High Flow Low Emission Hose End Valves PRODUCT UPDATE BULLETIN

This Product Update Bulletin Covers Enhancements to the following High Flow Low Emission Hose End Valve Models:

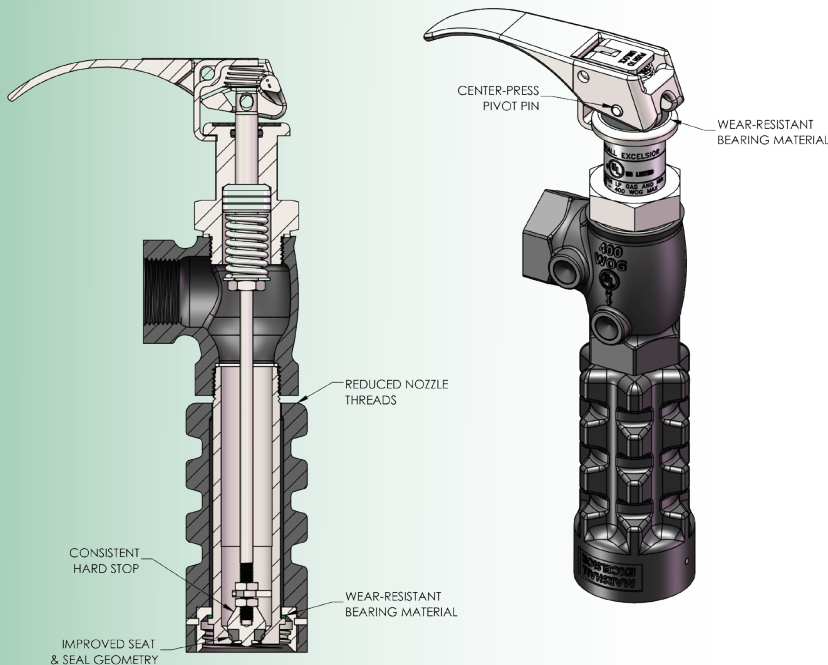
Marshall Excelsior has made five enhancements to these product models based on customer feedback. While the original design was listed to the stringent requirements of UL 125, Marshall Excelsior is committed to continuous product improvements that exceed the listing requirements and provide our customers with the product quality you have come to expect. We value the input from our customers and these product improvements are a direct response in our ongoing effort to provide you with the best service and quality possible.

- **Improved Seat & Seal Geometry:** Redesigned features to greatly improve durability and lifespan of the primary seal, as well as ease of opening.
- **Center-Press Pivot Pin:** Transferred rotational wear and opening forces to the handle instead of the central stem, for a larger bearing surface and improved operation while reducing wear.
- **New Bearing Materials:** Handle Thrust Bearing and ACME Coupler bearing now feature new materials that improve wear-resistance and product lifespan.

- Consistent hard stop to reduce variation in internal geometry
- Reduced nozzle threads give upper end of ACME coupling a better bearing surface
